FORD 4R100 "UPDATE HANDBOOK"

FORD 4R100 "UPDATE HANDBOOK"

Since the introduction of the 4R100 transmission in model year 1998, there have been many engineering changes to improve Pleaseability, Reliability and Durability concerns. These changes have affected most every part used in this transmission. This "Update Handbook" will explain each change, the reason for the change, and any parts interchangeability concerns created by the change, along with any part numbers needed to update your transmission.

Figure 34

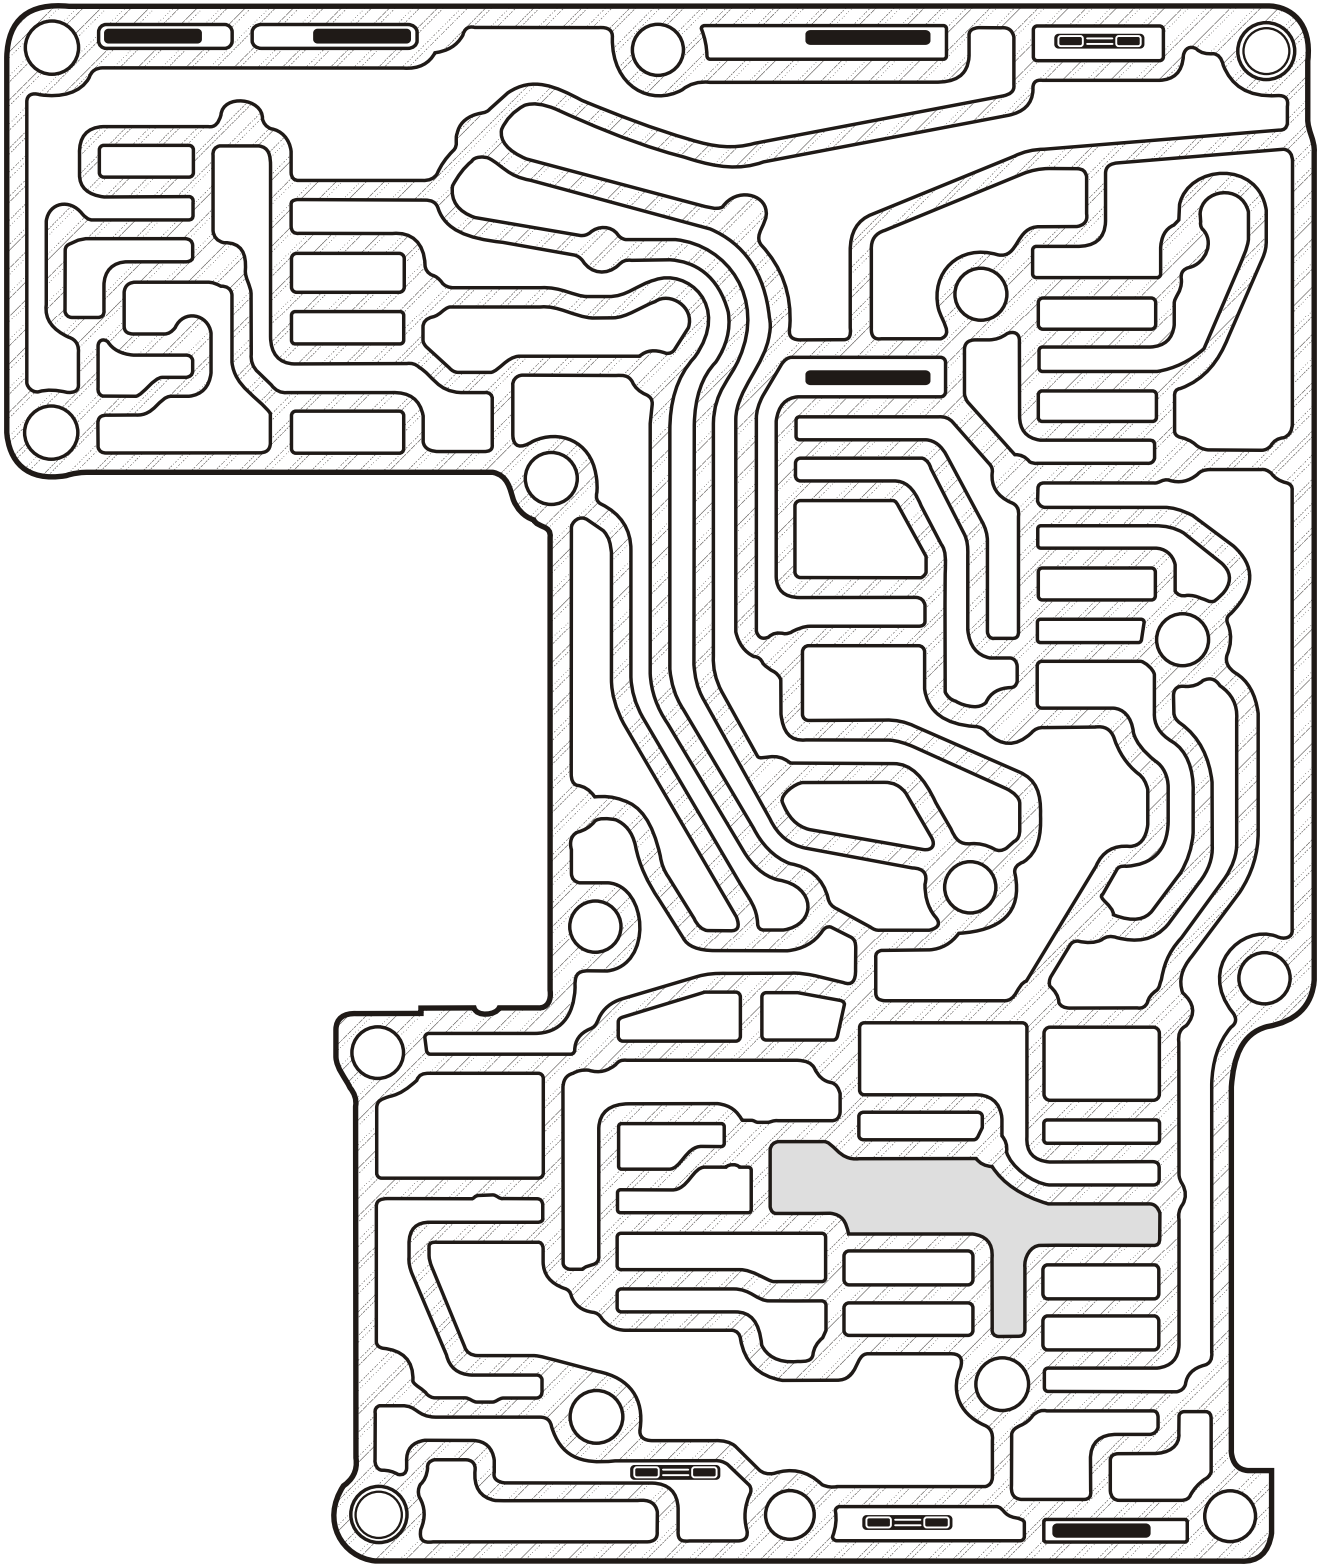
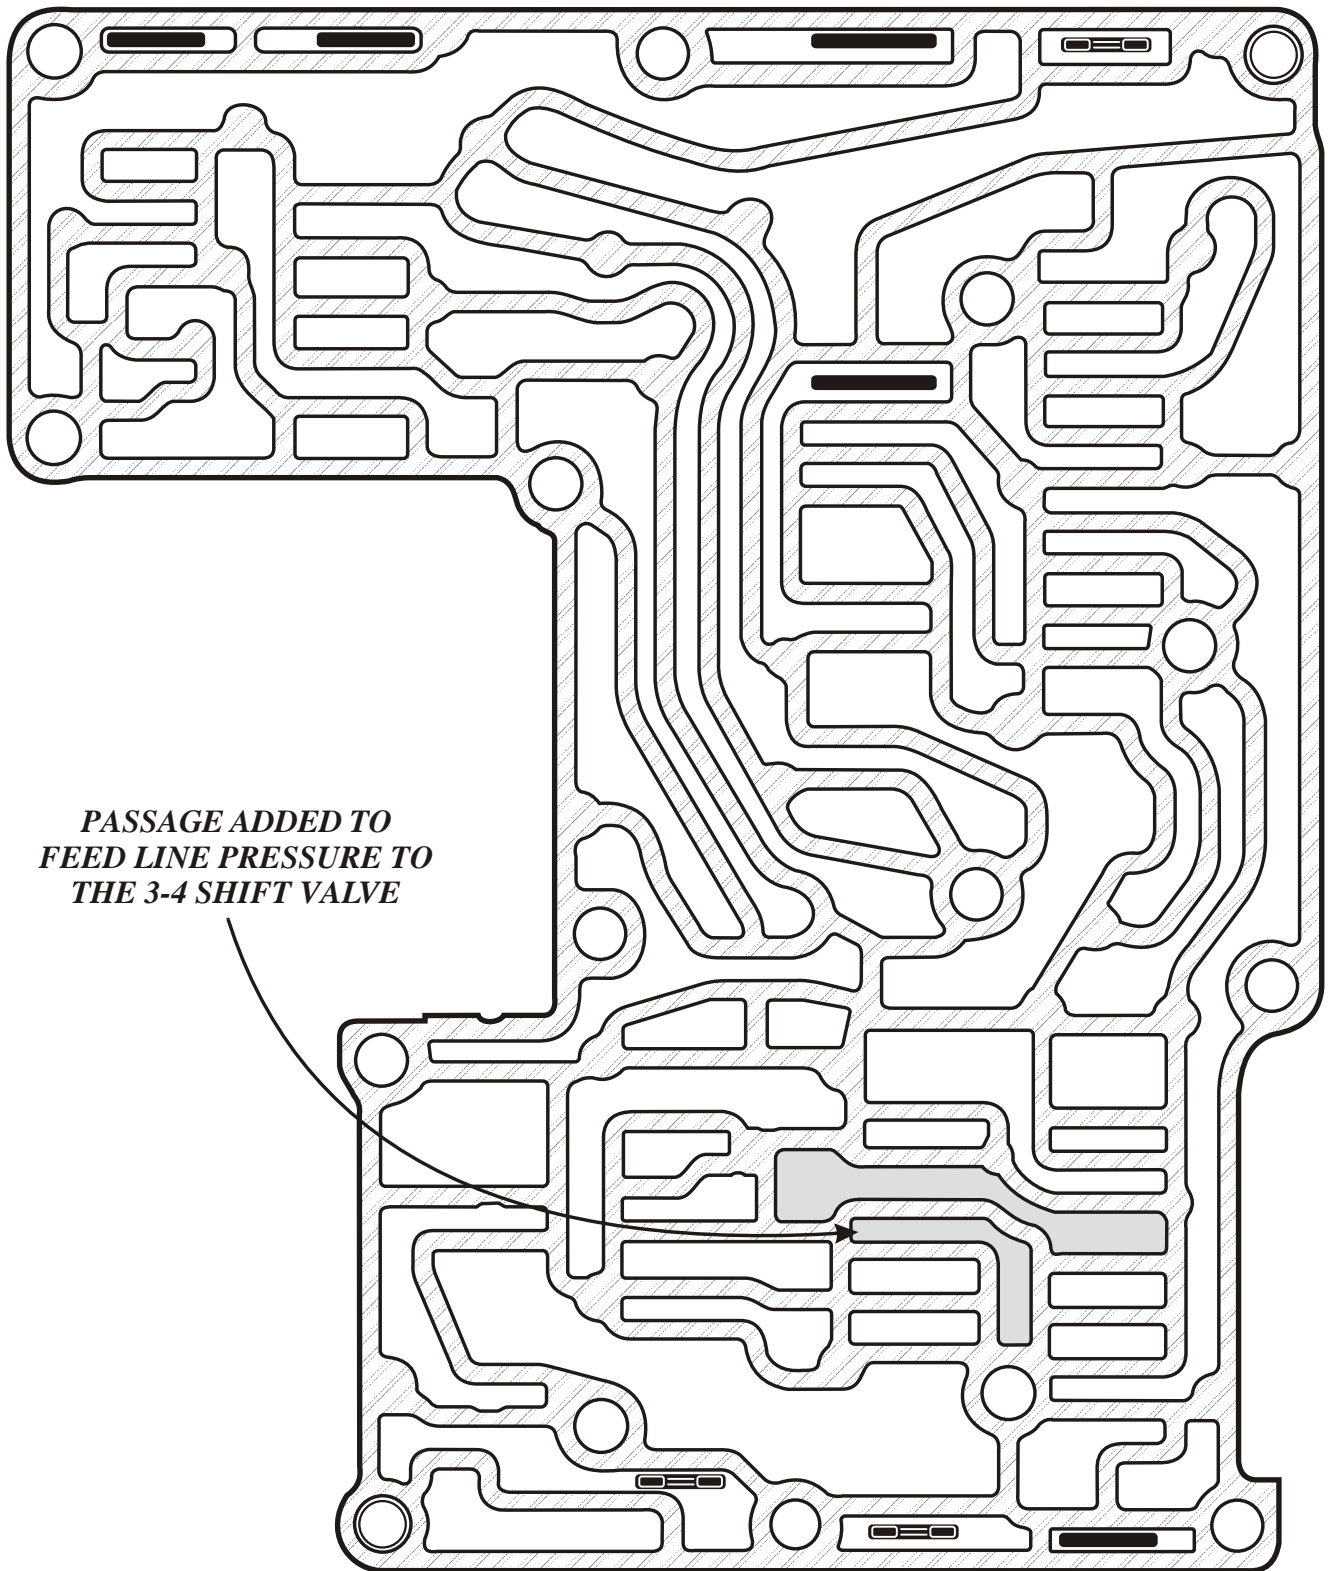
- (3) **MAIN VALVE BODY:** A passage was added on the "Upper Side" of the Main Valve Body on "PTO" versions, as shown in Figure 34, to supply Line Pressure to the 3-4 Shift Valve. A passage was also added, on the "Lower Side" of the Main Valve Body, to connect the 3-4 Shift Valve (Coast Clutch Circuit) to an exhaust as shown in Figure 36. The spring side of the 3-4 Shift Valve was also separated from the Low/Reverse circuit as shown in Figure 36. Refer to Figures 33 thru 36 for identification of "NON-PTO" and "PTO" Main Valvebody's.

*PASSAGE ADDED TO
FEED LINE PRESSURE TO
THE 3-4 SHIFT VALVE*

Figure 38

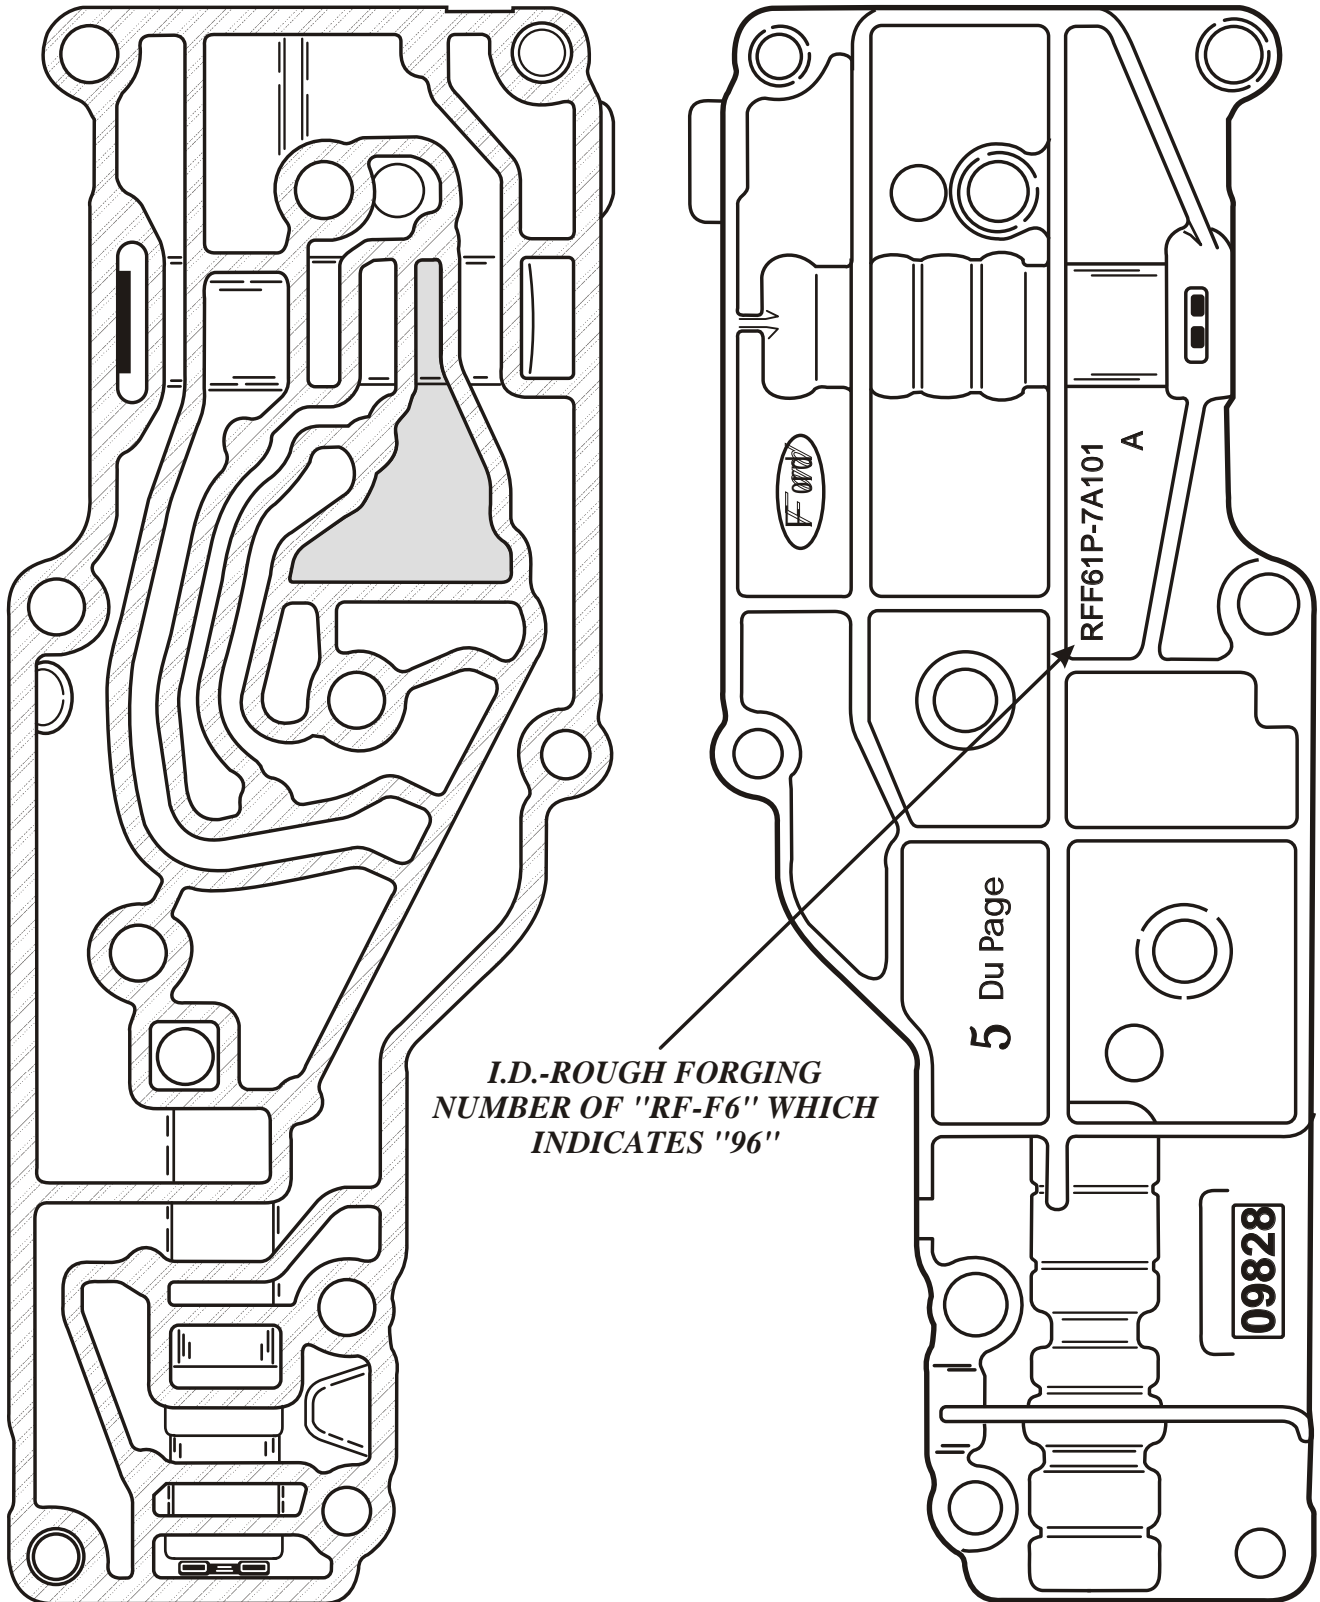
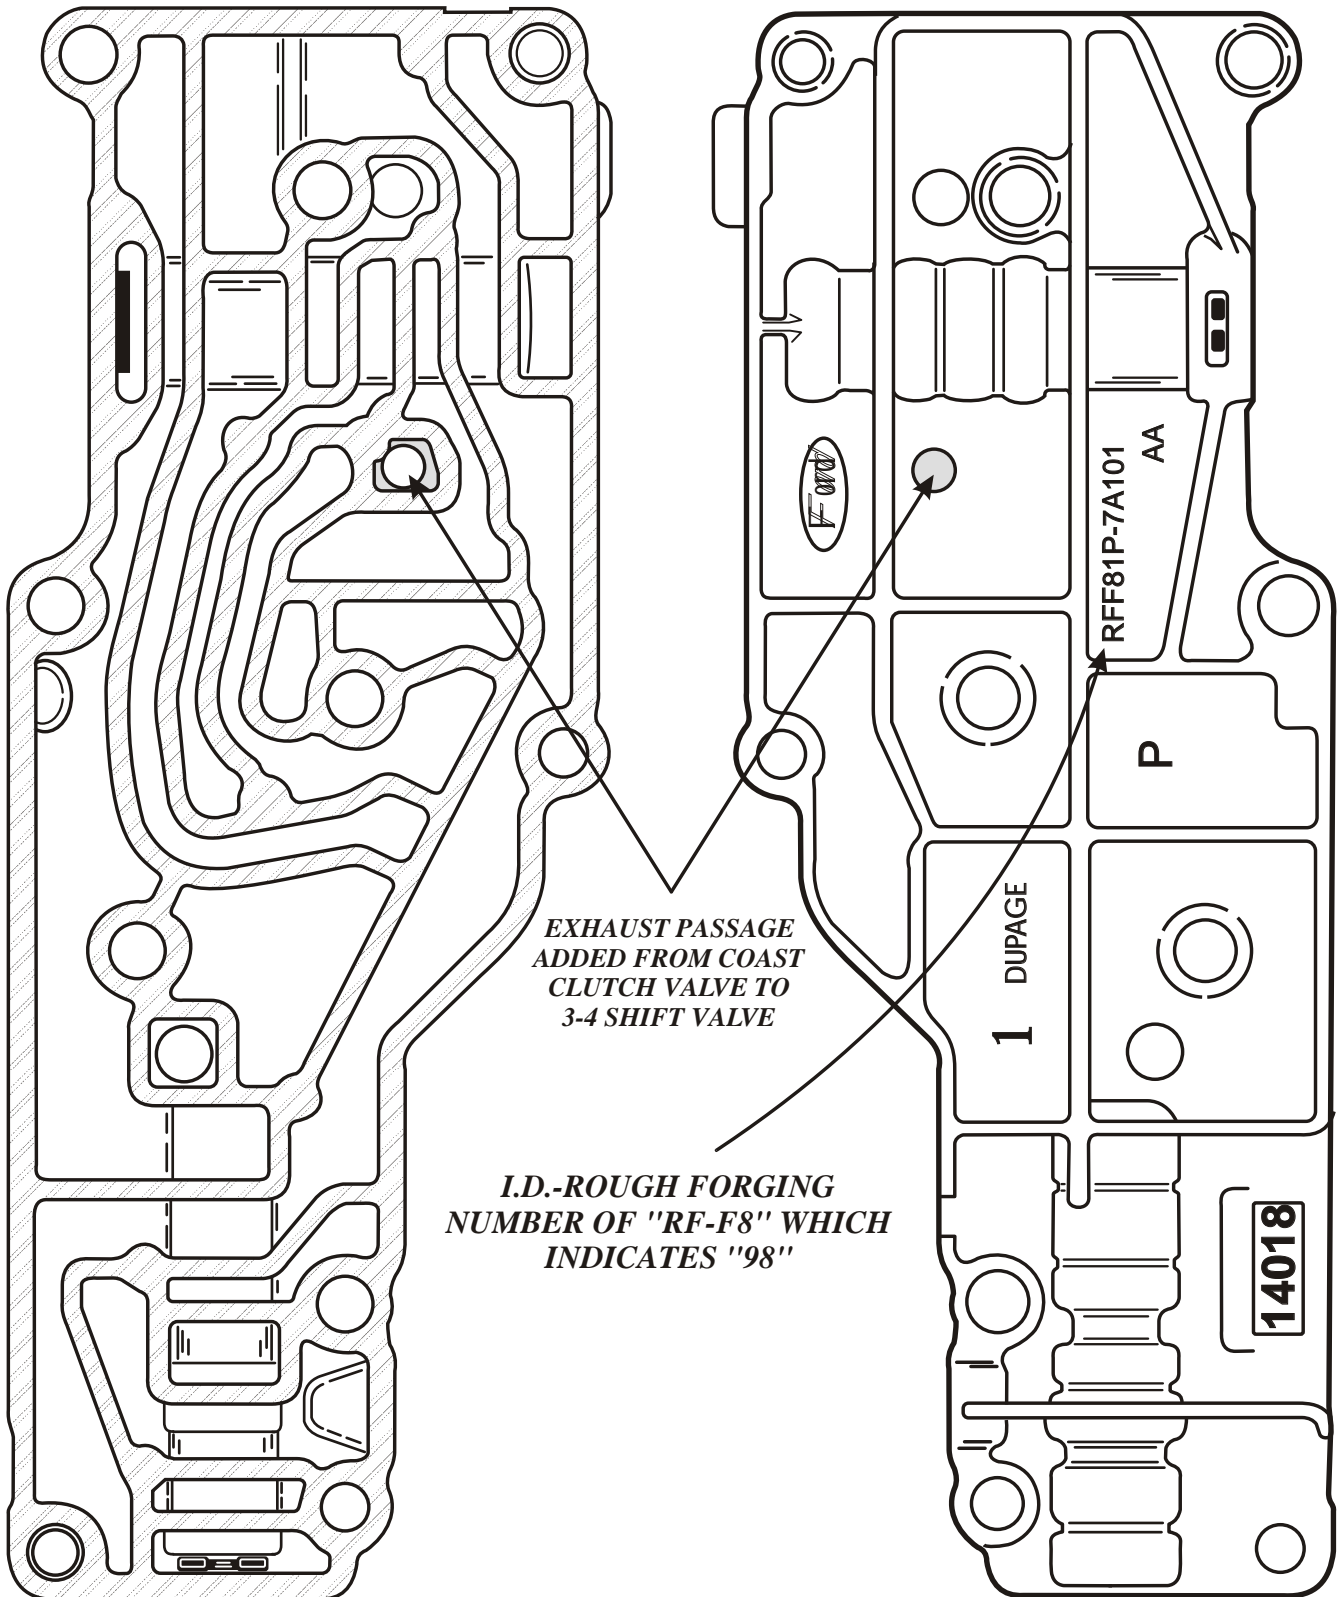
- (4) **LOWER VALVE BODY:** The Lower Valve Body had a passage added, as shown in Figure 38, to connect to the "new" exhaust passage in the Main Valve Body. Refer to Figures 37 and 38 for identification of "NON-PTO" and "PTO" Lower Valvebody's.

Figure 40

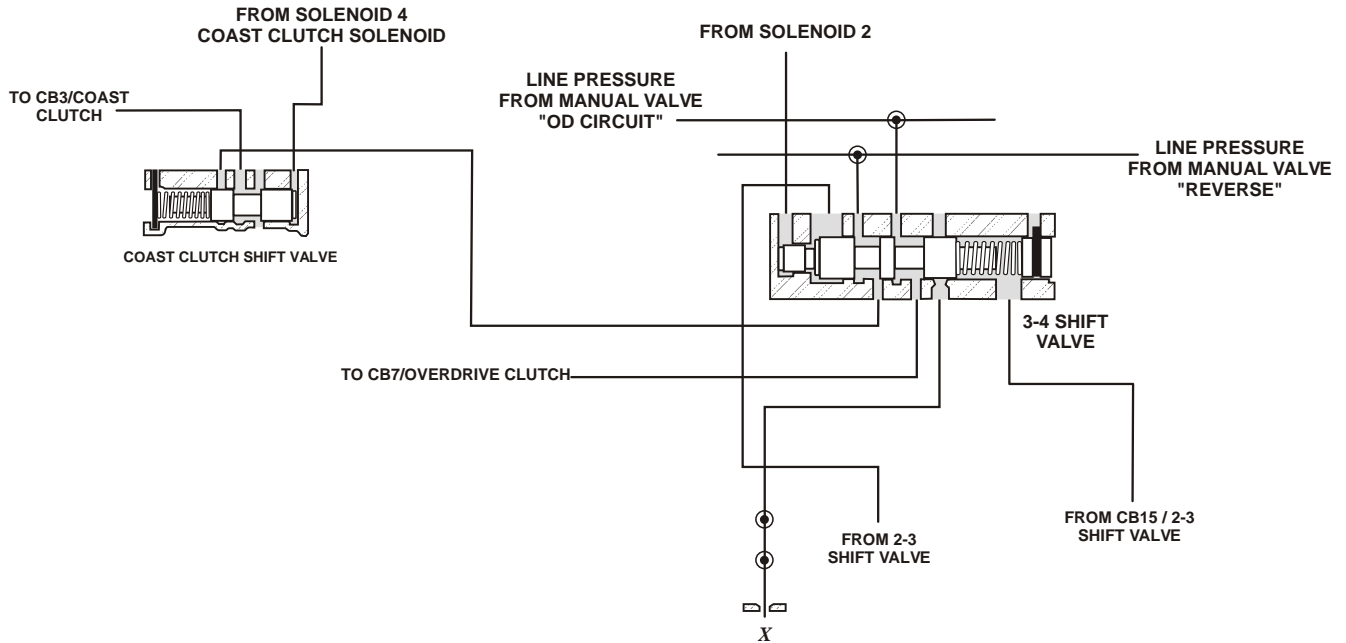
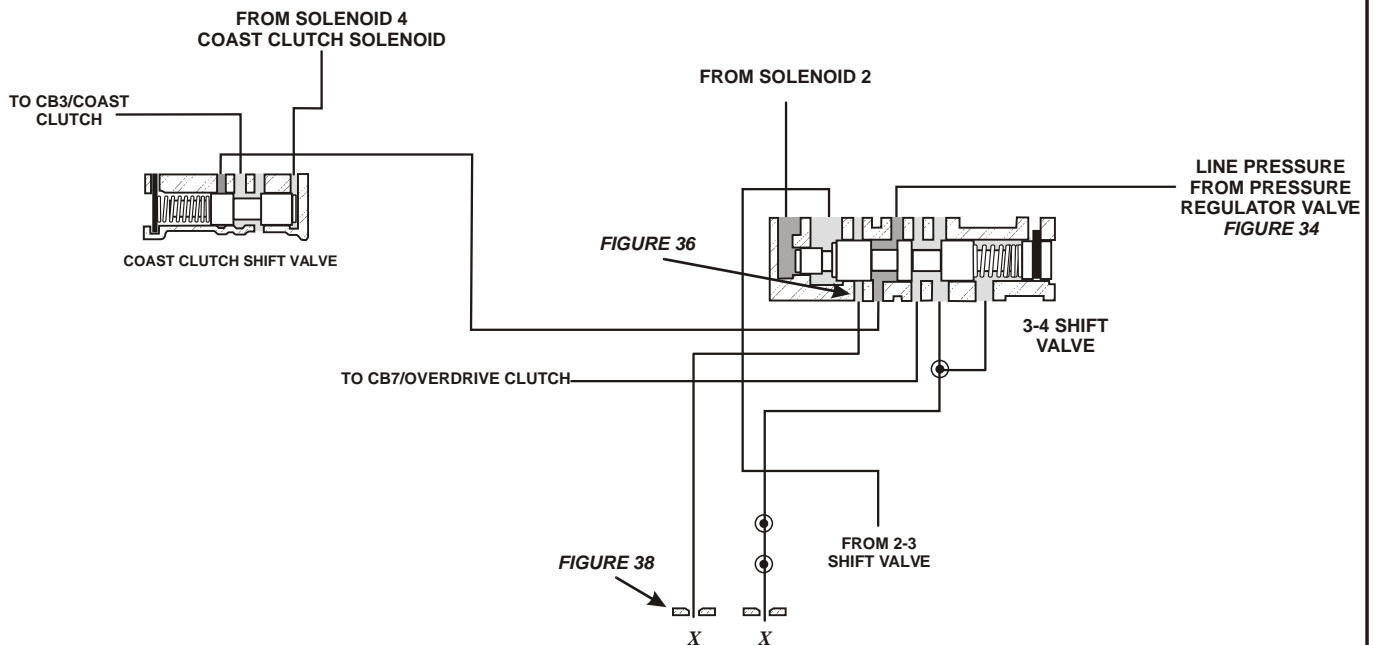
Partial Hydraulic Schematic is provided for you in Figure 40 on Page 49.

Figure 41

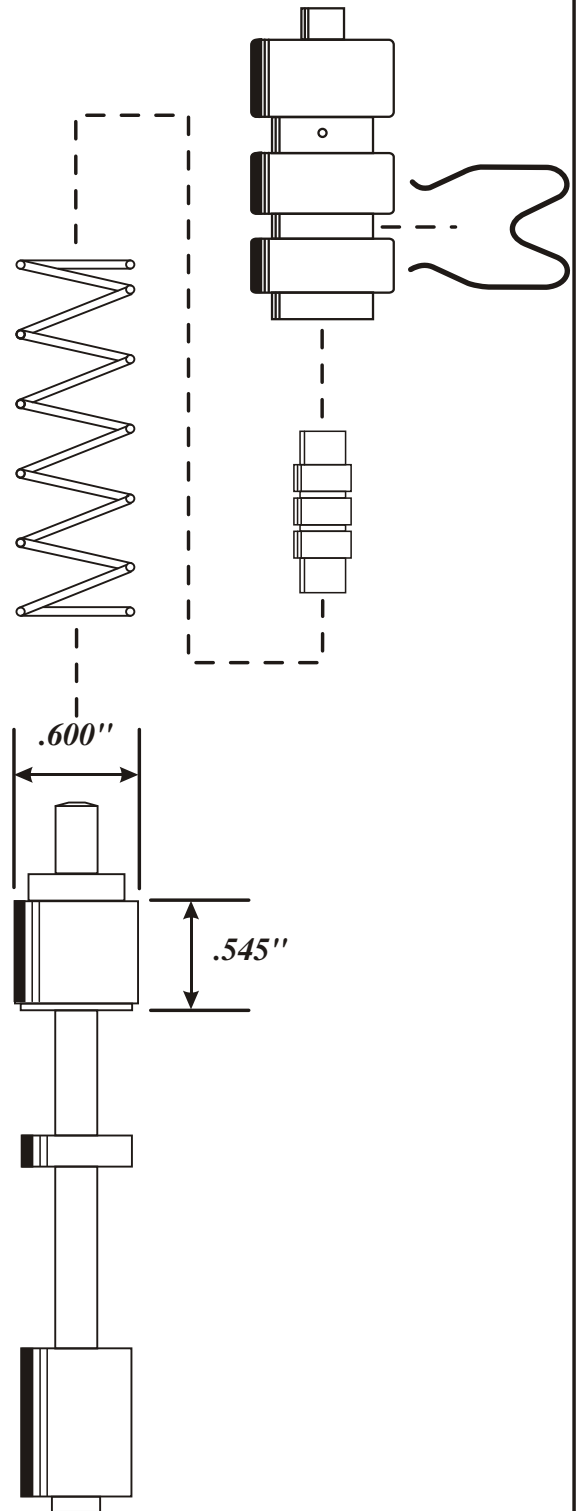
- The pump cover assembly had the rear of the Converter Clutch Valve bore enlarged approximately .070" to accommodate the enlarged land of the Converter Clutch Valve, as shown in Figure 41.

- A .036" orifice and an air bleed were added to the TCC Solenoid signal passage, as shown in Figure 43.
- The Converter Clutch Control Valve's rear spool was enlarged approximately .070". There was also a bushing and valve added to the end of the valve train, as shown in Figure 41.

THE DIAMETER AND THE LENGTH OF THE SPOOL ON THE VALVE LAND SHOWN ABOVE, WERE INCREASED ON PWM VERSIONS. THE BORE IN THE PUMP WAS ALSO ENLARGED APPROXIMATELY .070" TO ACCOMMODATE THE CHANGES IN THE DIAMETER OF THE VALVE
